ATTACHMENT A  
NINE MILE POINT UNIT 1  
TECHNICAL SPECIFICATIONS  
TABLE 3.6.2i

DIESEL GENERATOR INITIATION  
Limiting Condition for Operation

## ATTACHMENT B

### Response to Staff Questions

FIGURE 1  
(ORIGINAL DESIGN)

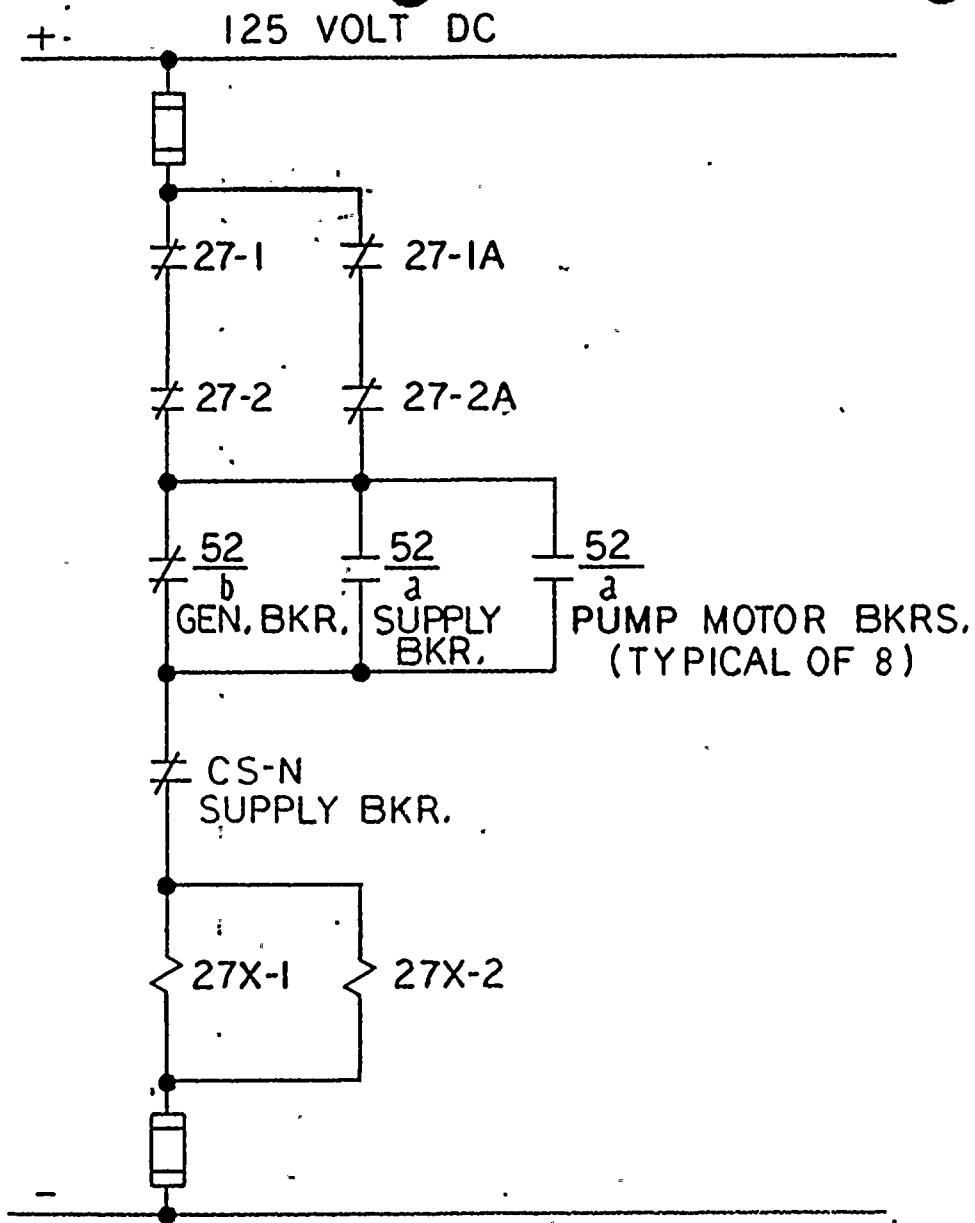
Our submittal of March 27, 1984 described the modification of the undervoltage protective relaying circuits for powerboards 102 and 103. We are now supplying revised figures to further clarify the modification design. This modification changed the logic used to monitor degraded voltage and loss of voltage (two out of three instead of two out of two logic). In addition, the circuits now monitor phase-to-neutral voltage instead of phase-to-phase voltage. The time characteristics previously reviewed by your staff, however, have not been significantly changed. Table 1 below shows the average time voltage characteristics of these relays. These characteristics are similar to those listed in our January 28, 1983 submittal. Therefore, the conclusions of our voltage profile analysis submitted on January 28, 1983 regarding the station electric distribution system remains essentially unchanged.

FIGURE 3  
(REVISED DESIGN)
